January 26th, 2017  
Peru State College, Theatre and Event Center Renovation and Addition  
Peru, Nebraska

-----  
**ADDENDUM**

**1 FIRST FLOOR - POWER**  
E2.1 1/8" = 1'-0"

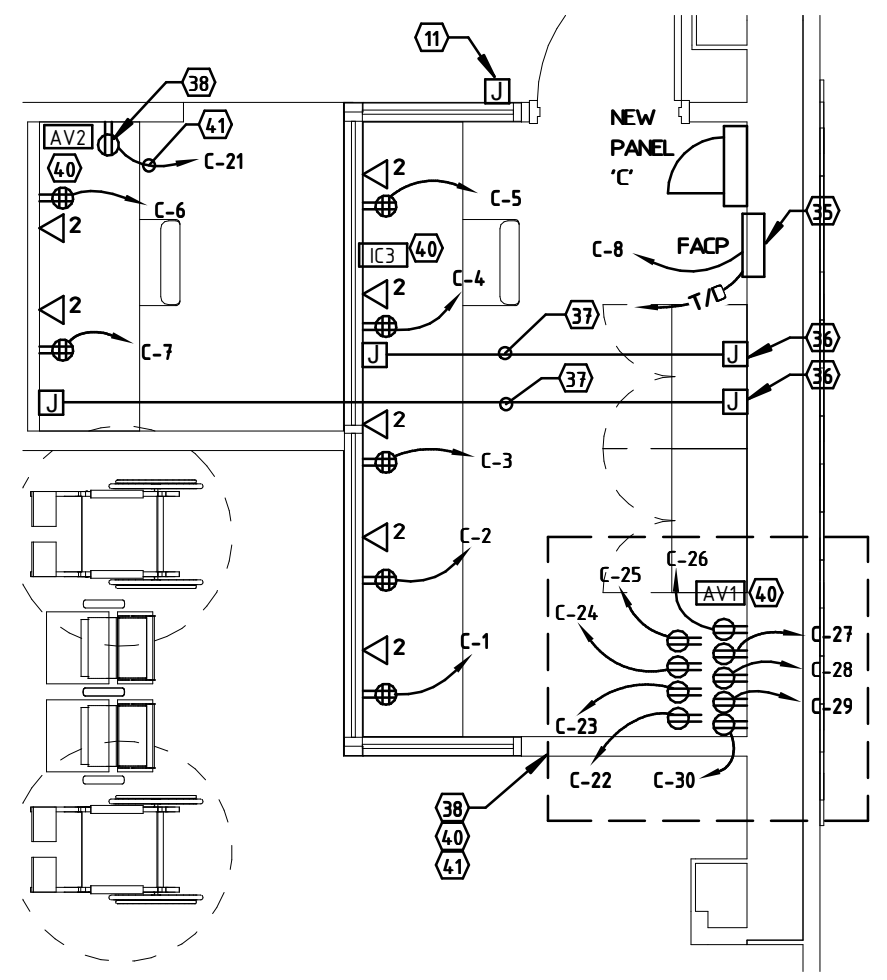
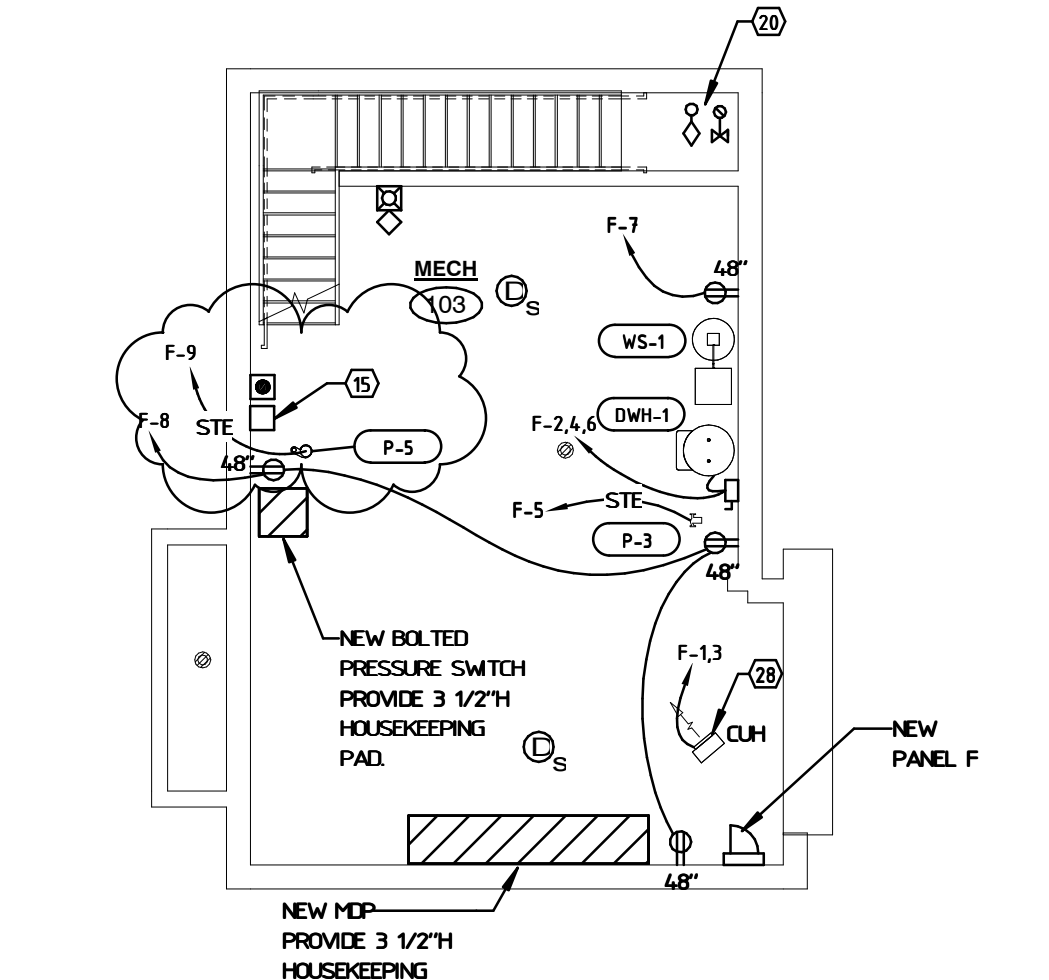
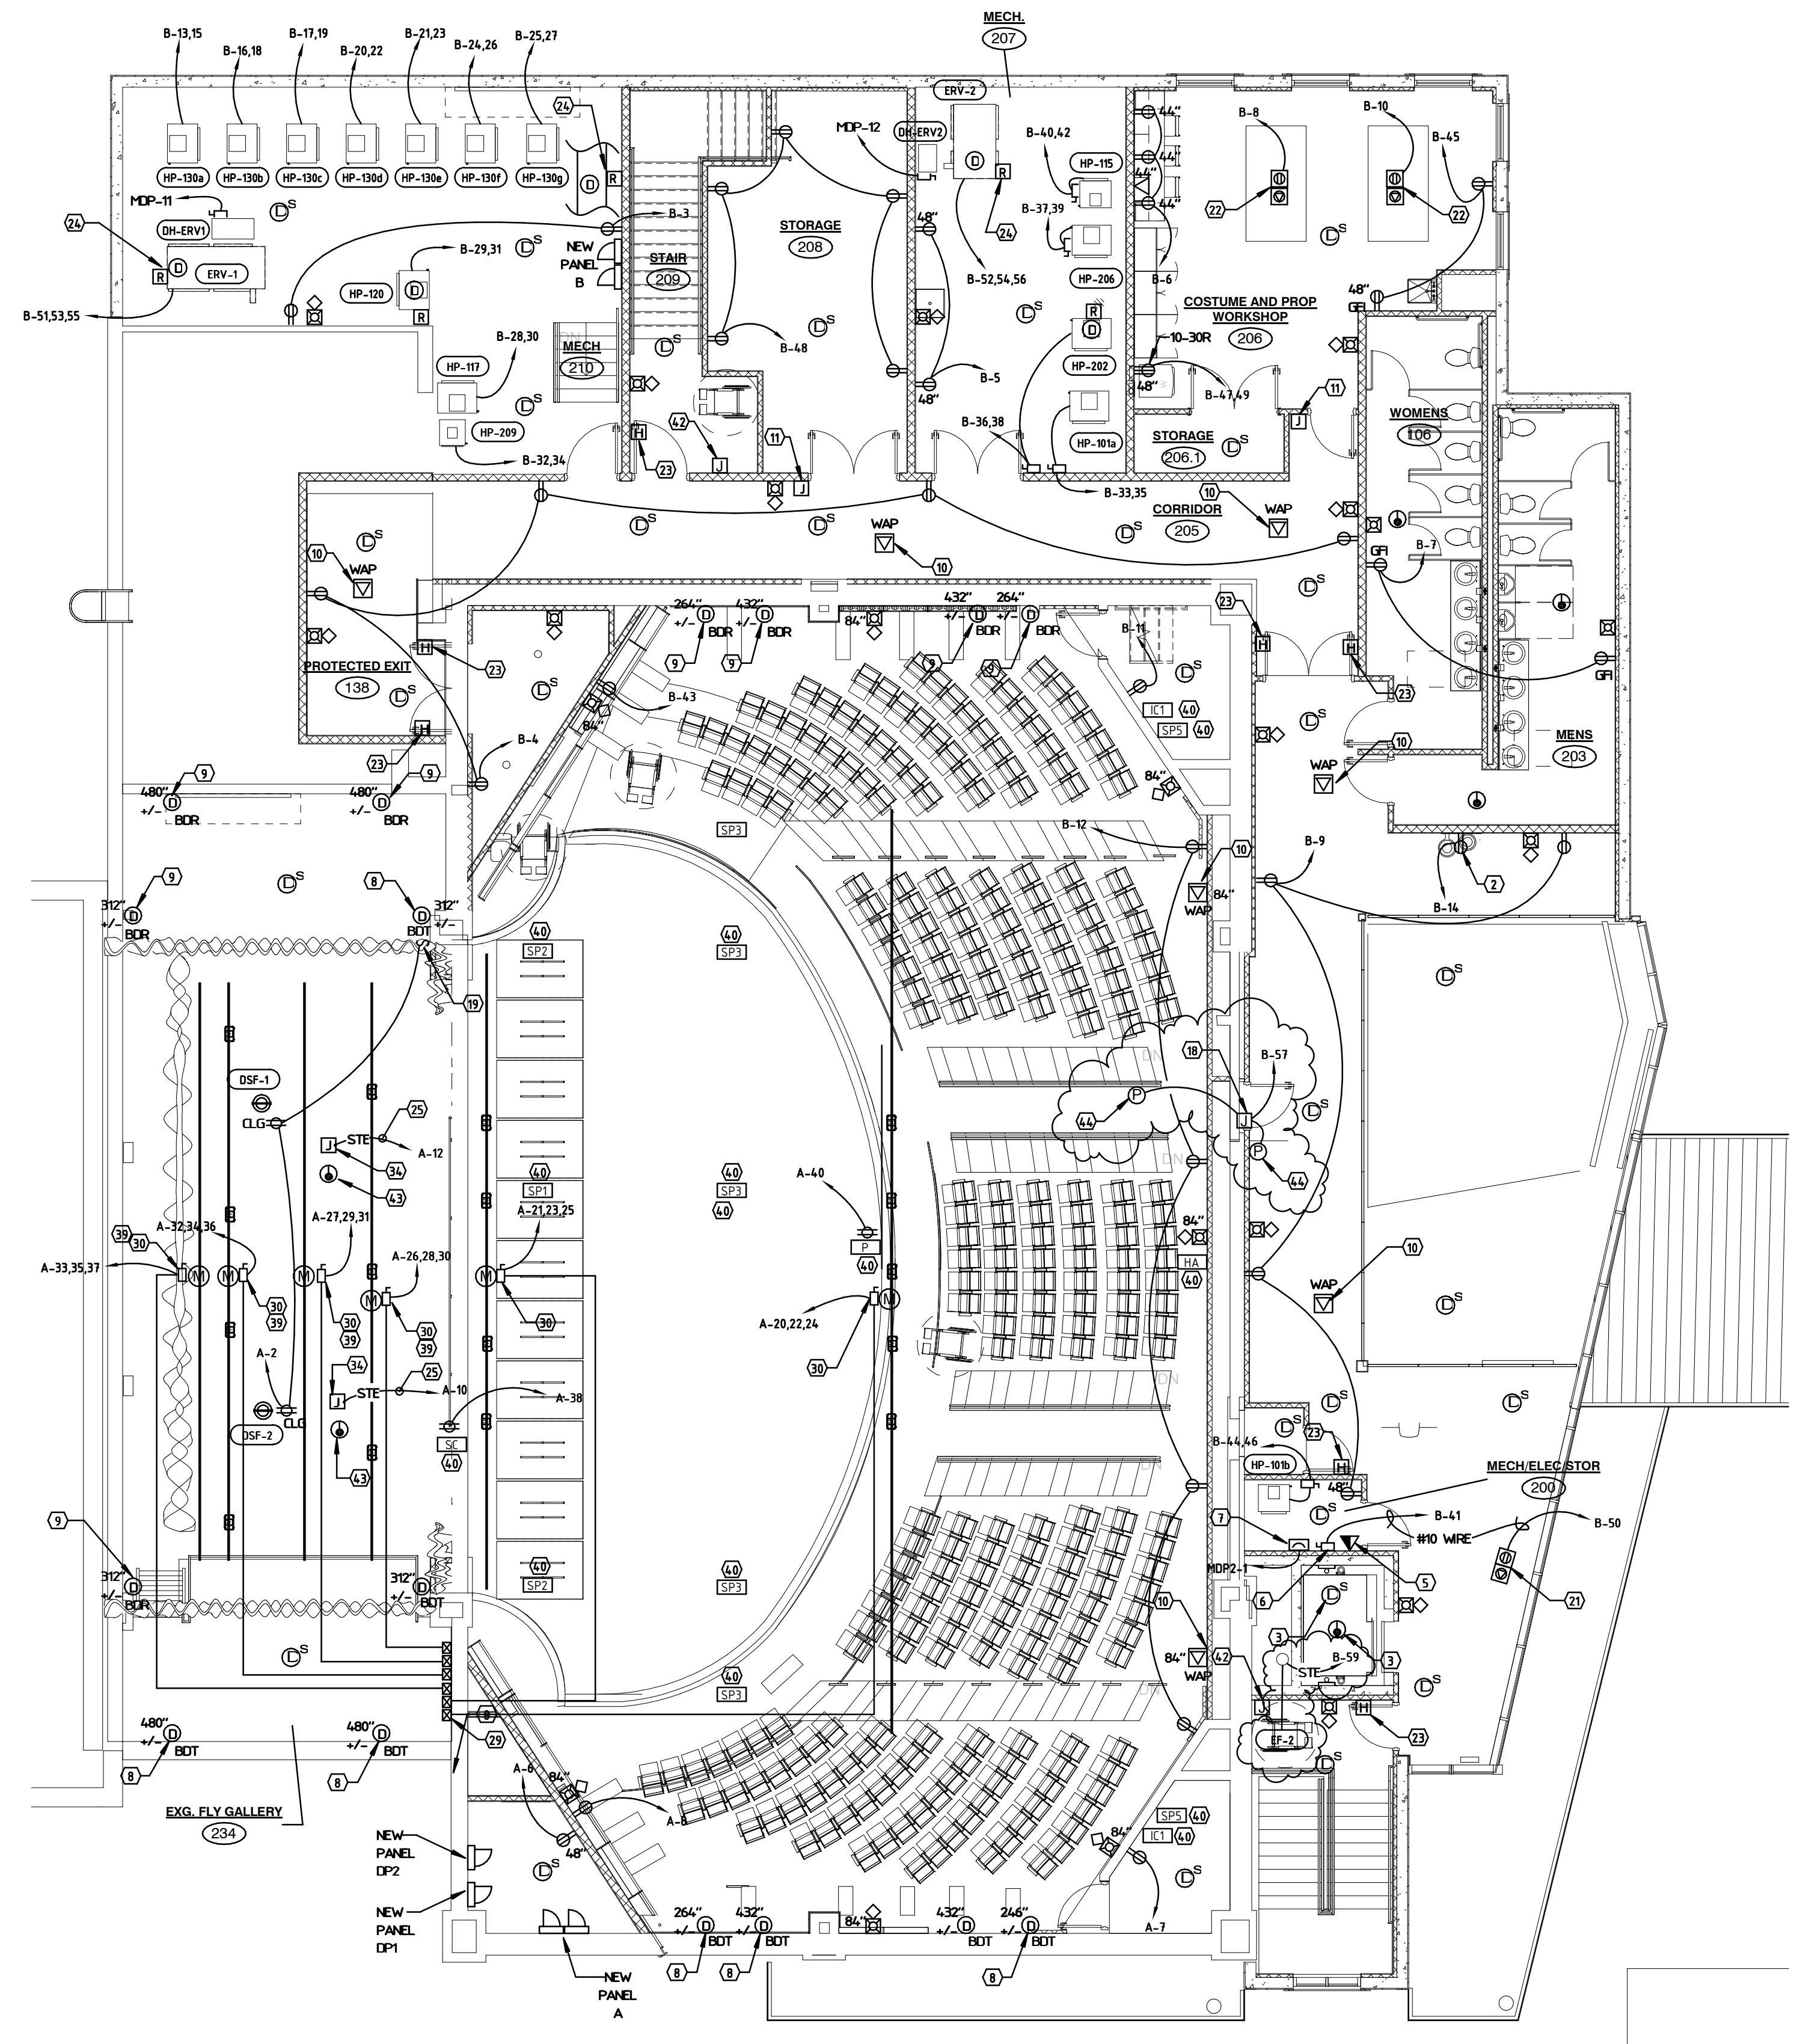
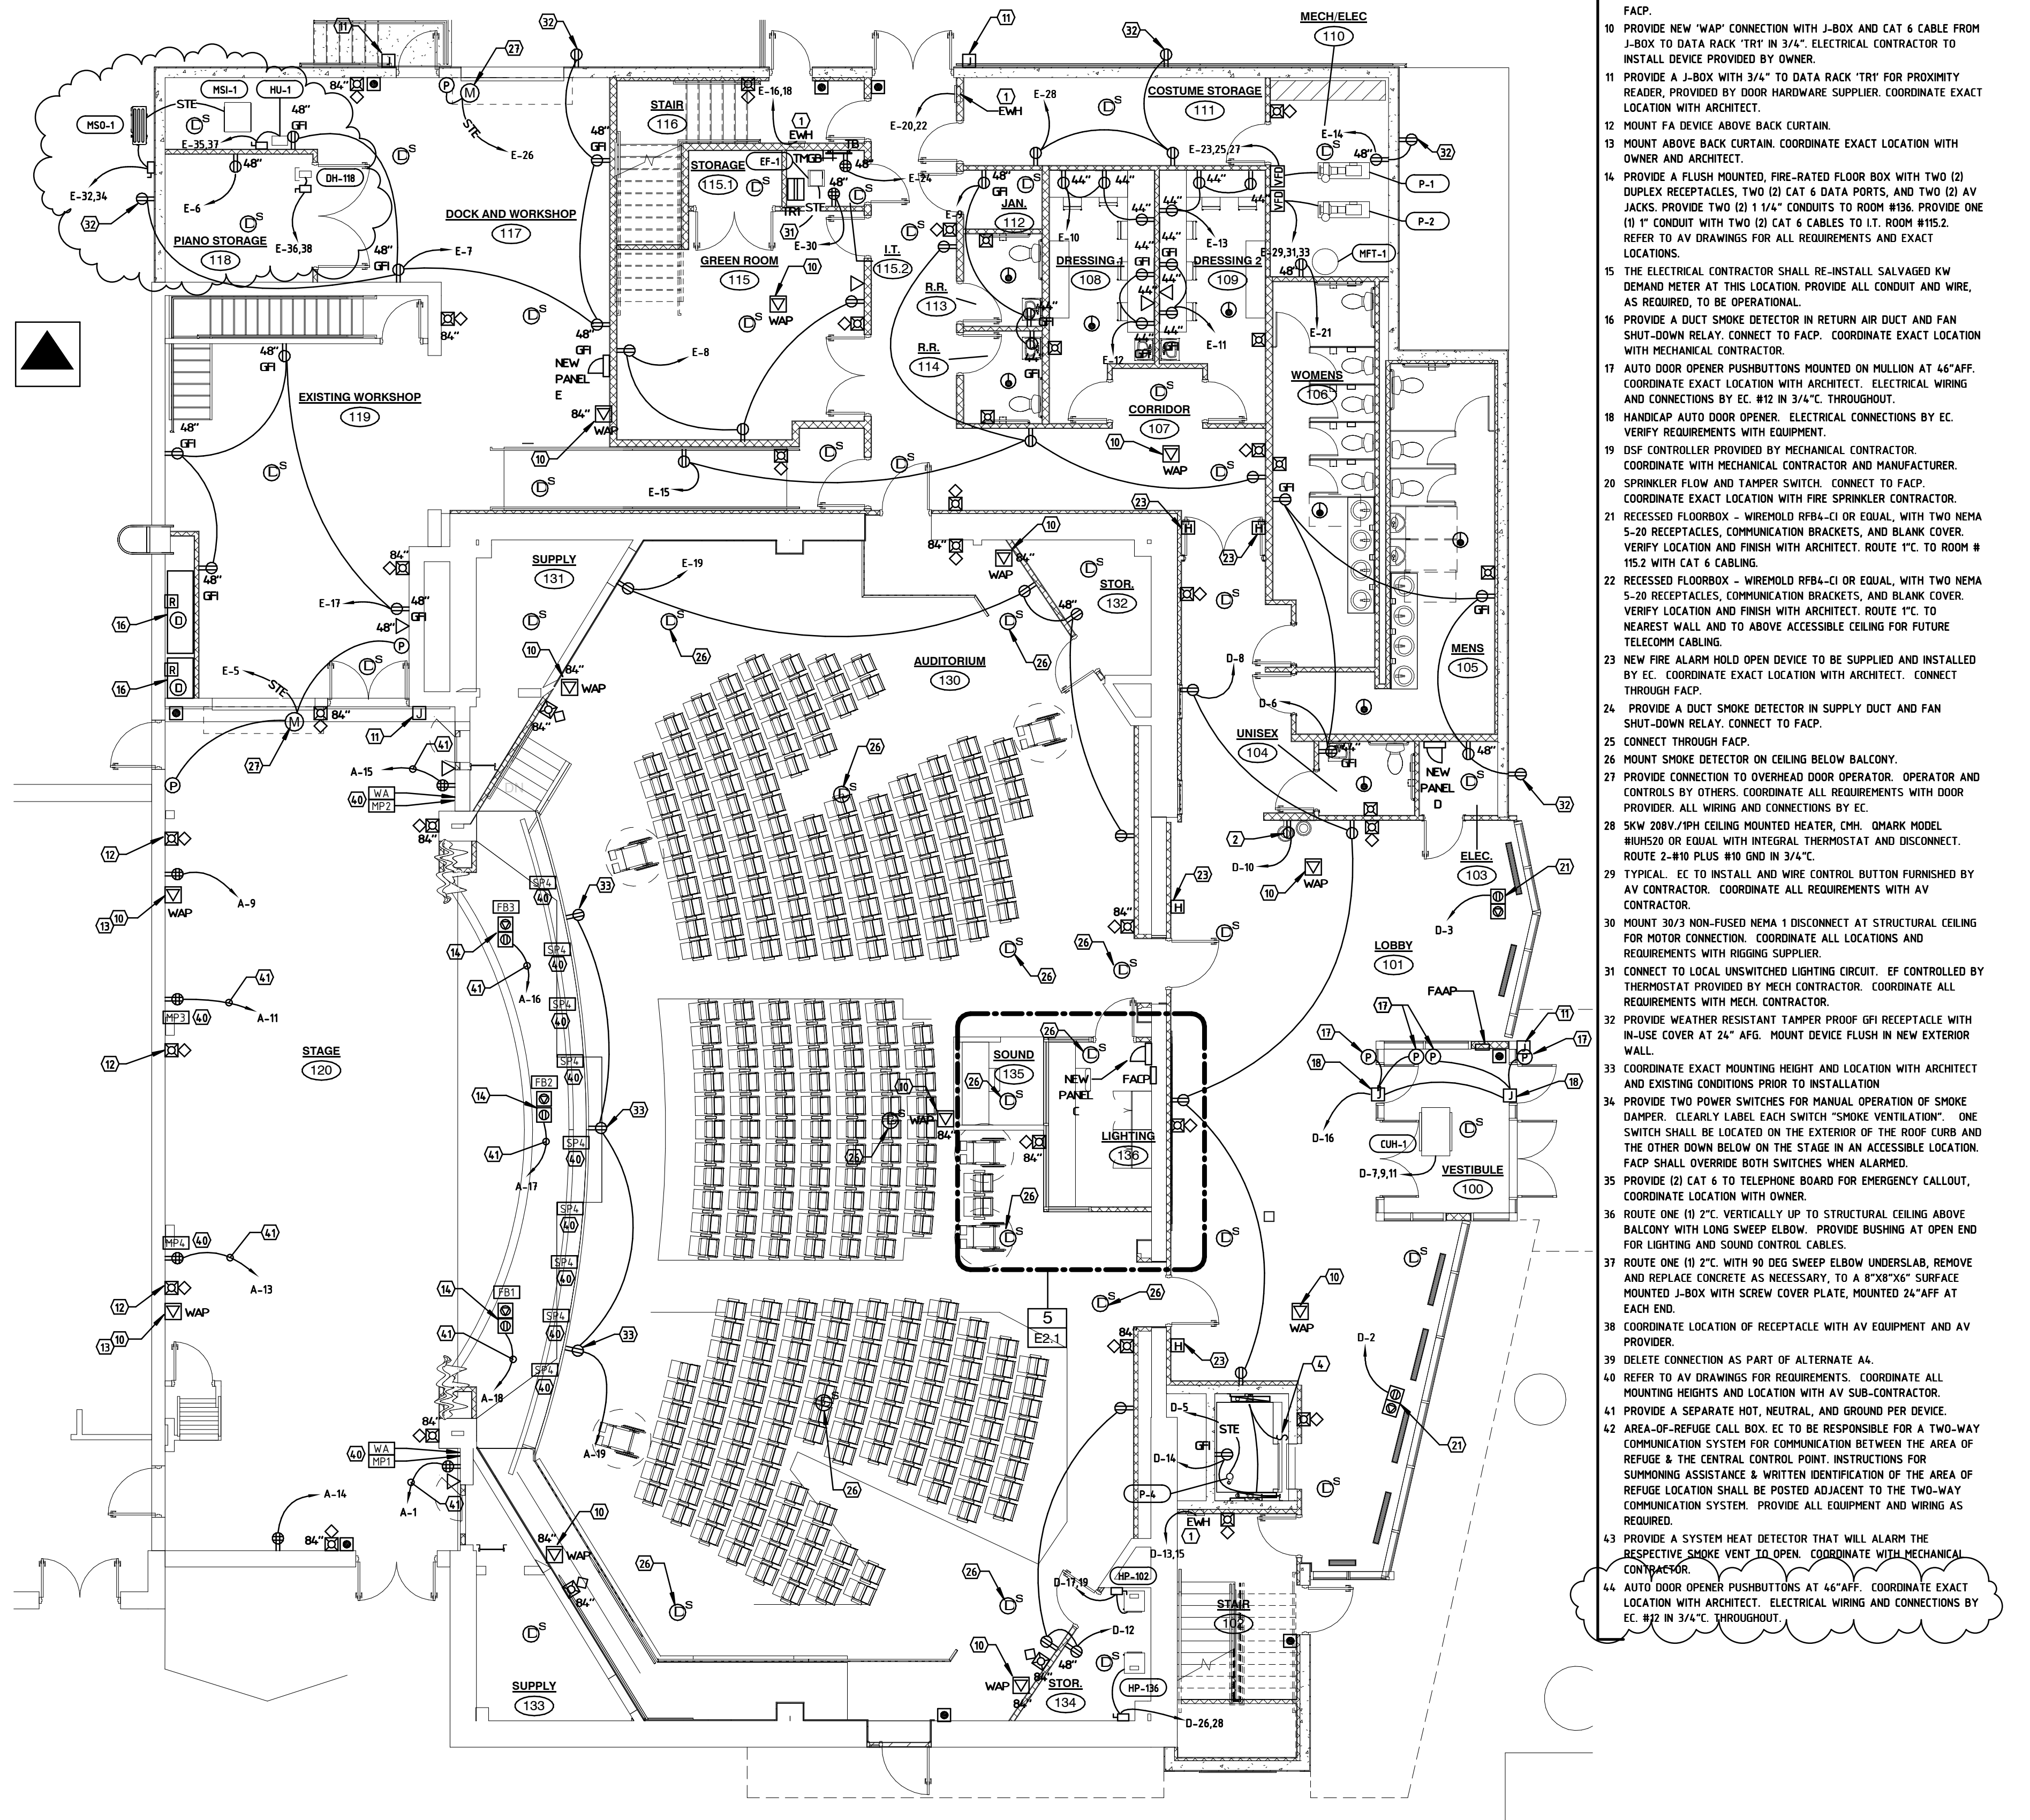
- 1) Added electrical connection for HU-1. Provide NEMA 1 non-fusible disconnect with 2-#12 and #12 gnd in 3/4" conduit to new 20/2 breaker in Panel 'E'. Remove two 20/1 spare breakers from Panel 'E'.
- 2) Added electrical connection for EF-2. Provide STE with 2-#12 and #12 gnd in 3/4" conduit to spare 20/1 breaker in Panel 'B'.
- 3) Added electrical connection for P-5. Provide STE with 2-#12 and #12 gnd in 3/4" conduit to breaker in panel "F" that was serving the existing sump pump.
- 4) Remove all electrical connections to existing sump pump in basement
- 5) Remove door hold open. Provide connections to automatic door opener specified by architect.

**EXISTING ELECTRICAL VAULT STRUCTURAL DETAIL**  
NOT TO SCALE

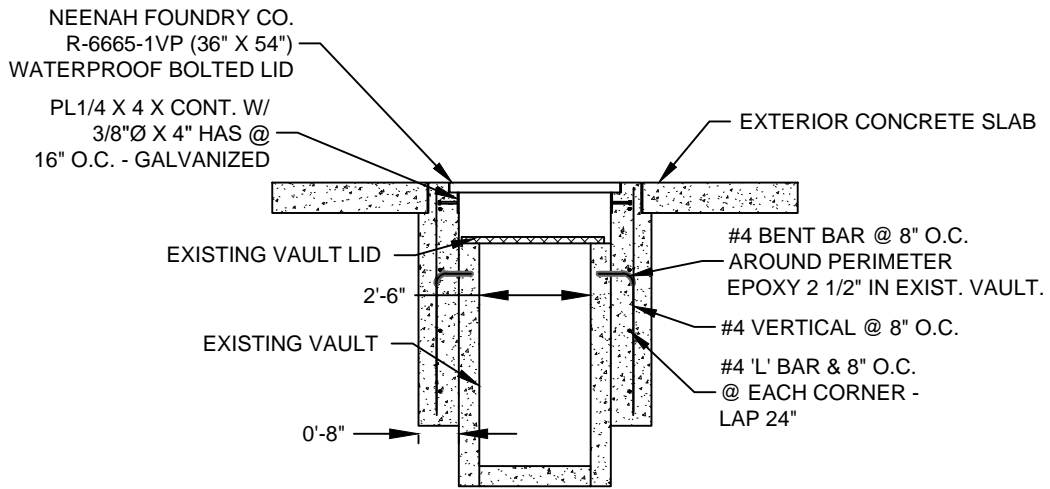
- A. Replace Sheet C1.1 with attached C1.1 – See bubbled areas Noted with revision tags.

- A. Replace Sheet C4.1 with attached C4.1 – See bubbled areas Noted with revision tags.
